# Access Compliance Report

## Public Rights-of-Way

| Intersection ID: 49553                  | Main Street: STEEL_GARDENS_BV | Cross Street: WARREN_BURGESS_LN         | Location: SW           |
| ADA ID: 0AE148711D13                    | Ramp Type: Perp               | Initial Pass/Fail: Fail                 | Overall Compliance: No |

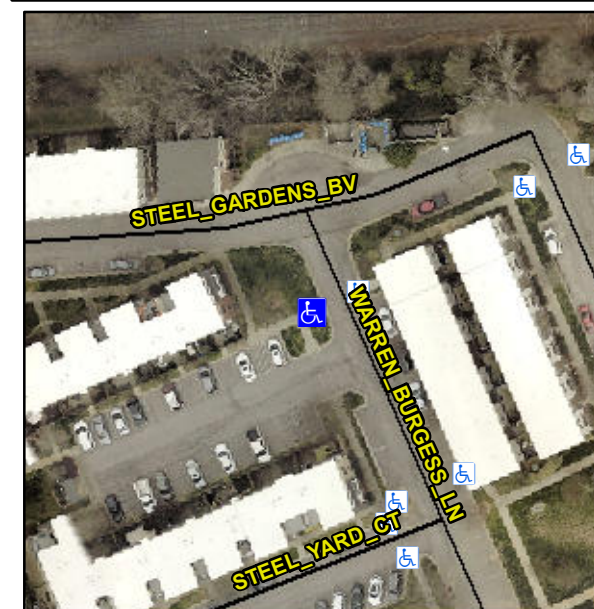
**R304.5.3**

| Compliance | Description           | Data | Compliance | Description                 | Data |
|------------|-----------------------|------|------------|-----------------------------|------|
| Yes        | Ramp Width (in)       | 49.0 | No         | Ramp XSlope (%)             | 3.6  |

**Remove & Replace Entire Ramp.**
